Subject:       Compilation of Geotechnical Submittals  
                  **Skyview Estates**  
                  Hazard, Kentucky  
                  Project Number: 24020013SHE

VECTOR Engineers, Inc. was requested by the Kentucky Finance Cabinet to review and provide value engineering/opinion report on the initial geotechnical report by L.E. Gregg and Associates entitled “Geotechnical Engineering Exploration, Sky View Estates, Perry County Kentucky.” After submission of the review and at the request of KYTC, Vector was contracted by HMB Professional to provide geotechnical engineering consulting during the design and preconstruction phase. As requested, this document provides a compilation of the geotechnical submittal to be provided with the bidding documents.

As requested, Vector Engineers, Inc. conducted a review of the report entitled, “Geotechnical Engineering Exploration, Sky View Estates, Perry County Kentucky” by LE Gregg Associates dated March 1, 2023. The purpose of the review was to provide preliminary recommendations for site preparation and foundation recommendations for the proposed residential development. This letter does not supersede the information presented

Figure 1: Rough profile sketch of mine spoil thicknesses

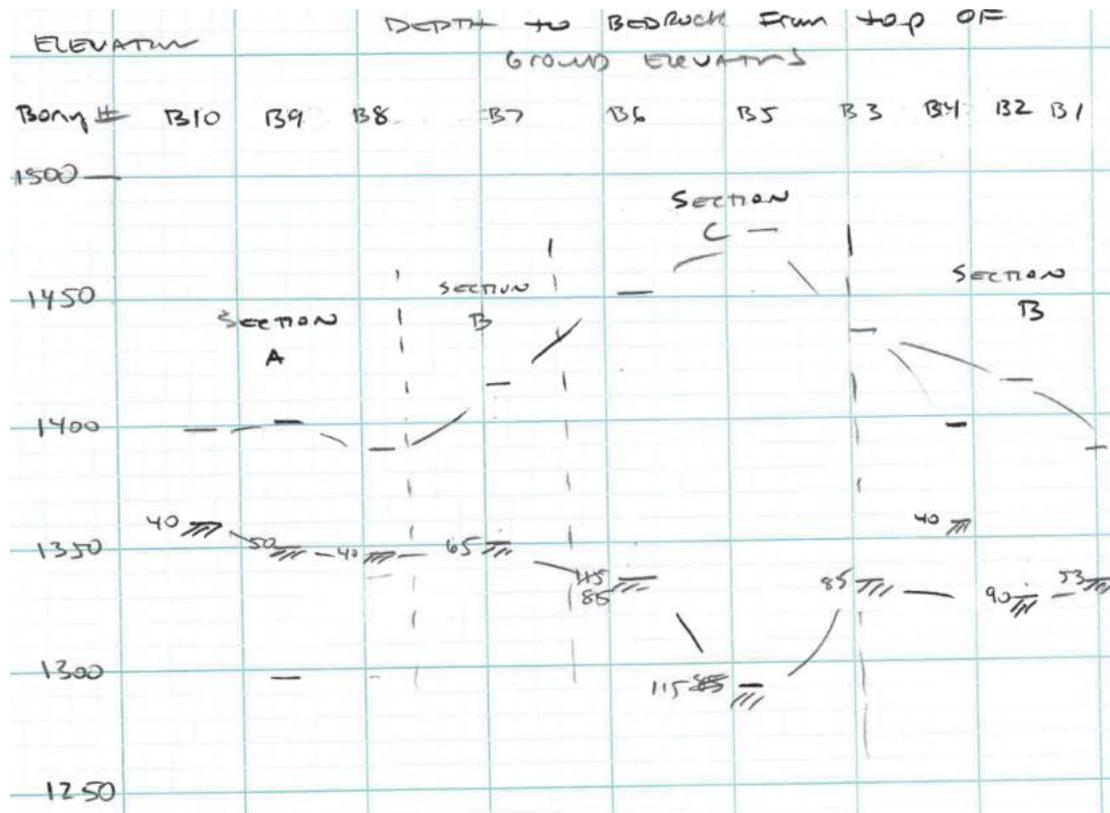
Upon review of the boring data, the site ranges in elevation from about 1400 feet msl to 1470 feet msl. The bedrock depths range from 40 feet to about 115 feet which corresponds to elevation of about 1560 ft msl to 1290 feet msl. A rough profile is shown in Figure 1.

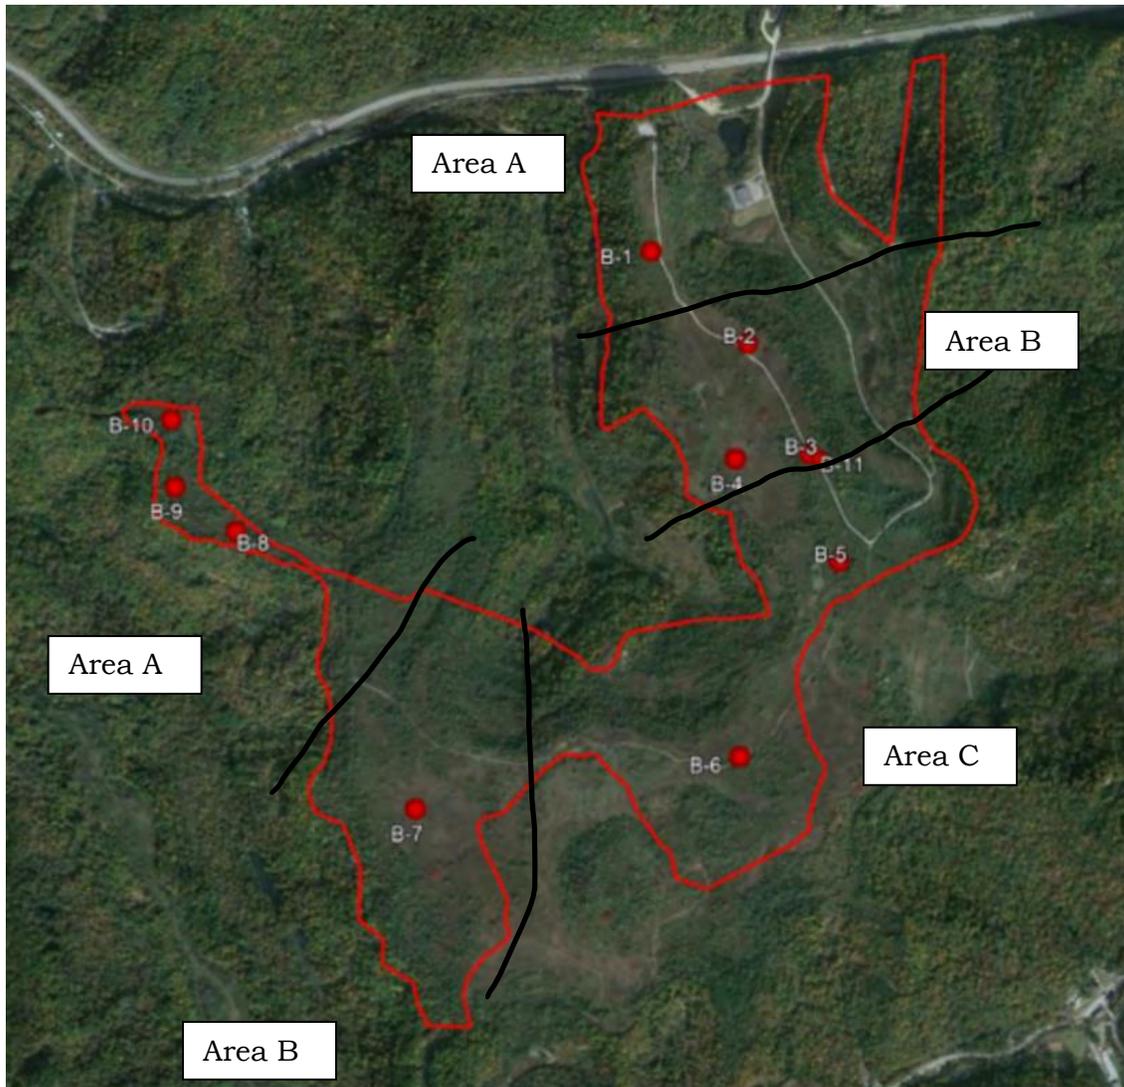
Based on the depths from the borings, an interpretation of the depths resulted in dividing the site into three distinct areas. Area A is for portions of the site with mine

spoil fill depths less than about 50 feet, Area B is for portions of the site with mine spoil fill depths greater than 50 feet but less than about 75 feet and Areas C for portions of the site with mine spoil fill depths from 75 feet to about 115 feet. The drawing in Figure 2 shows the general areas identified from the boring data. From the limited boring data, there appears to be three distinct bedrock elevations. The bench in area A is about elevation 1350 ft, the bench in Area B about 1325 and in Area C, the mine spoil may have been placed in an old valley.

To reduce the risk of differential settlement, the mine spoil fill thickness must be consistent beneath any individual building footprint. Also, the depth to bedrock must also be relatively consistent beneath any proposed building location. The building must not straddle areas of large variations in bedrock depths between benches or be located over a site with a partially buried mine bench. Individual buildings should be completely in one specific Area as shown on Figure 2.

Figure 2: Aerial photograph via Google Earth with the KMZ of the approximate boring locations provided by LE Gregg, the endpoint MASW lines provided by NSG, and the planned development provided by HMB.

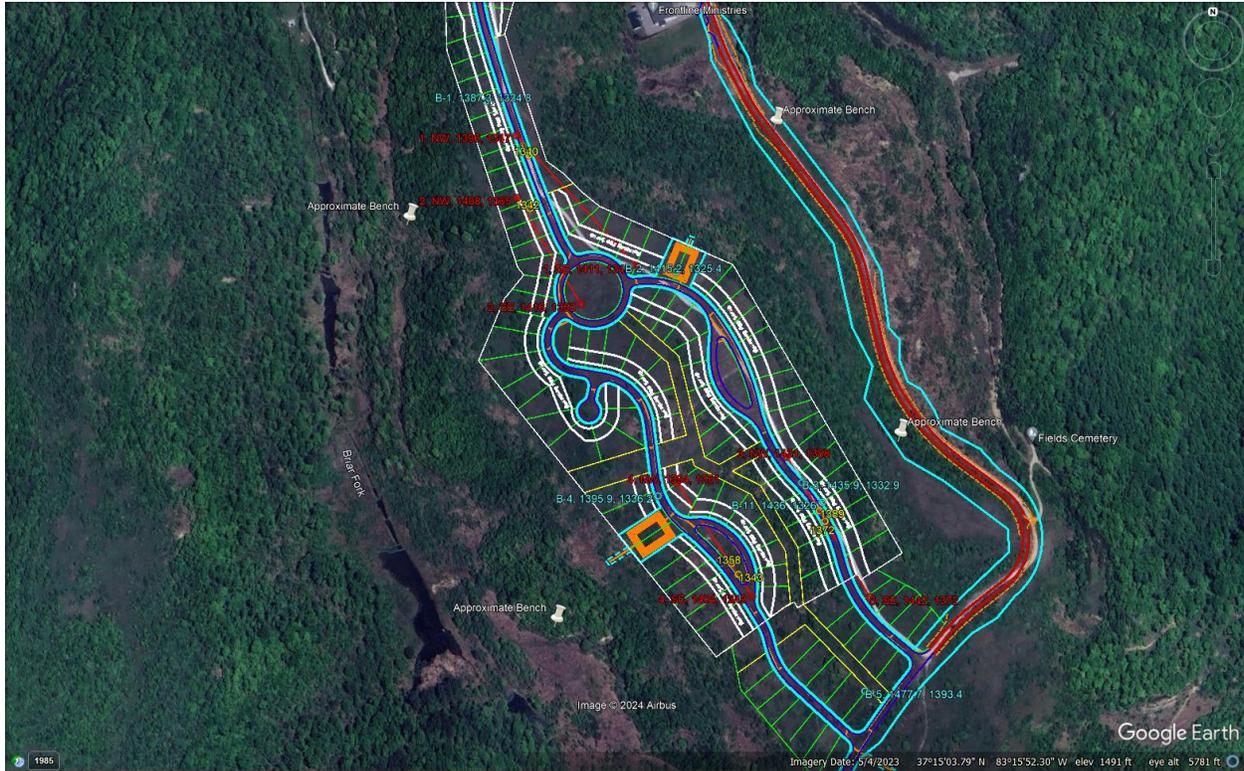
As discussed the meeting, minor benches of approximately 10 to 20 feet in height were observed in Lines 1, 2, 3, and 4 running northwest to southeast. Based on the boring logs, the refusal/bench depths in B-1, B-2, and B-4 are relatively consistent with Lines 1, 2 and 4.

Based on the overlay with the proposed development, Line 3 generally follows the planned roadway. Assuming that Borings B-3 and B-11 are located at the toe of the bench, then the residential lots east of the road overlay relatively consistent spoil depth
